**Re: Response to Information Request  
 Development Application seeking a Development Permit for Material Change of Use – Health Care Service (Doctors Clinic) and Dwelling Unit on land described as Lot 55 on T11884 and located at 30 Paxton Street, North Ward**

## Information Request

Application no:	MCU25/0103
Assessment no:	0234026
Proposal:	Dwelling Unit & Health Care Services
Street address:	30 Paxton Street NORTH WARD QLD 4810
Real property description:	Lot 55 T 11884
Applicant's reference:	M2592

#### Request Item 3 - Amend layout plan with vehicle dimensions and swept paths

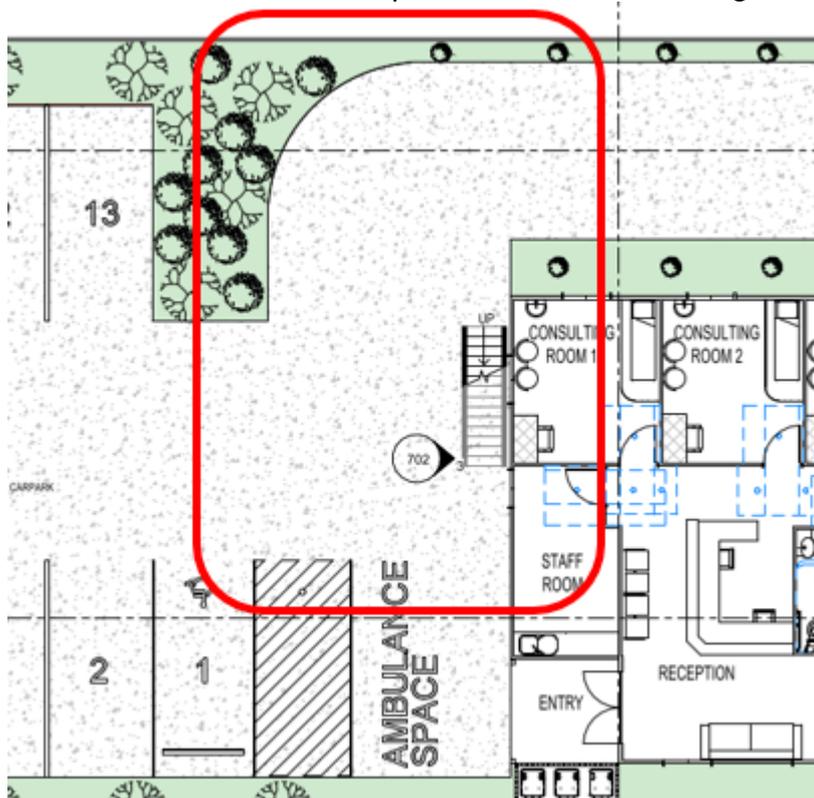
The applicant is requested to provide an amended plans detailing the following:

- Driveway dimensions and layout in accordance with AS2890.1, or otherwise provide vehicle movement swept paths from a qualified RPEQ demonstrating that passenger vehicles and an ambulance can be parked and satisfactorily manoeuvre without undue conflict with pedestrians and other vehicles; and
- Vehicle swept paths for an MRV service vehicle, demonstrating that it can safely and conveniently enter and exit the rear section of the site for occasional loading/unloading.

*It appears that the narrow section of driveway (4.44m width), tight 90-degree bend, and rear building stairway may result in poor visibility, inconvenient and/or unsafe passenger vehicle manoeuvring, and potential safety risks for pedestrians. This is also likely to be particularly problematic for the occasional ambulance or service vehicle accessing the rear of the site. Consideration should be given to relocating the rear stairway, widening the driveway, reducing the driveway bend angle, the need for a dedicated ambulance space and/or other measures to improve on-site manoeuvring.*

<b>Item 3</b> Amend layout plan with vehicle dimensions and swept paths	<p>This item requested to provide an amended plans detailing the following:</p> <ul style="list-style-type: none"><li>▪ Driveway dimensions and layout in accordance with AS2890.1, or otherwise provide vehicle movement swept paths from a qualified RPEQ demonstrating that passenger vehicles and an ambulance can be parked and satisfactorily manoeuvre without undue conflict with pedestrians and other vehicles; and</li><li>▪ Vehicle swept paths for an MRV service vehicle, demonstrating that it can safely and conveniently enter and exit the rear section of the site for occasional loading/unloading.</li></ul> <p>In response to this item, it is noted that the proposed driveway has a minimum width of 4.44 metres. In accordance with AS2890.1, curved driveways are required to have a width between 3.0 metres and 5.5 metres. The proposed driveway width therefore complies with the acceptable range prescribed by the standard.</p> <p>While concerns have been raised regarding the narrow driveway section, 90-degree bend and proximity of the rear stairway, these matters can be appropriately addressed through detailed design and conditions of approval. A condition can require the submission of certified swept path diagrams prepared by a qualified RPEQ demonstrating that:</p> <ul style="list-style-type: none"><li>▪ Passenger vehicles can safely enter, manoeuvre and exit the site</li></ul>

Item	Response
	<p>in a forward direction;</p> <ul style="list-style-type: none"><li>▪ An ambulance can access the site and undertake turning movements as required; and</li><li>▪ An MRV service vehicle can safely access the rear of the site for occasional servicing.</li></ul> <p>Should swept path analysis identify minor design refinements as necessary such as localised widening at the bend (which can be accommodated by reducing the landscaped area) or minor stairway adjustment, these can be incorporated at detailed design stage without altering the overall development intent. The matter is considered capable of being resolved by condition, with compliance to AS2890.1 and demonstrated vehicle manoeuvrability to be confirmed prior to operational works or building approval.</p>
<p><b>Item 4</b> Provide a concept stormwater plan</p>	<p>This item requested to demonstrate compliance with the Townsville City Plan and associated policy guidelines, including in particular PO10 and PO11 of the Healthy waters code by providing a concept stormwater plan demonstrating how site stormwater will be managed to not cause a new or increased nuisance along Paxton Street.</p> <p>This concept plan will address how runoff from the parking spaces, driveways, building roof, and any contributing runoff from upstream properties can be appropriately discharged to the road network (in accordance with QUDM requirements and without causing a nuisance to users of the verge and roadway).</p> <p>In response to this item, all stormwater runoff generated by the development, together with any contributing runoff from upstream areas, will be collected and directed toward the Paxton Street frontage for lawful discharge to the existing road drainage network, in accordance with the QUDM. A stormwater pit is located directly in front of 28 Paxton Street, providing an appropriate and established point of discharge.</p> <p>The stormwater management approach satisfies the intent of PO10, as the proposed development will not adversely affect the flooding or drainage characteristics of upstream, downstream, or adjoining properties. Stormwater will not be discharged onto neighbouring private land and no changes to overland flow paths effecting surrounding properties are proposed.</p> <p>The development also complies with PO11, as the design will ensure that runoff is conveyed in a controlled manner that avoids ponding and does not result in changes to flow rates or velocities that could adversely affect the safety, use or enjoyment of nearby properties, the road verge, or the roadway. The increase in impervious area will not result in nuisance to pedestrians or vehicles using Paxton Street, as flows will be appropriately captured and discharged to Councils infrastructure.</p> <p>Given the nature and scale of the development, it is considered appropriate that the stormwater plan be prepared during the Building Works or Operational Works Stage, when final site level, drainage infrastructure and construction details are confirmed. Accordingly, it is proposed that the provision of a concept stormwater management plan be secured as a condition of approval, with detailed design to be submitted and approved prior to the commencement of the use or as part</p>
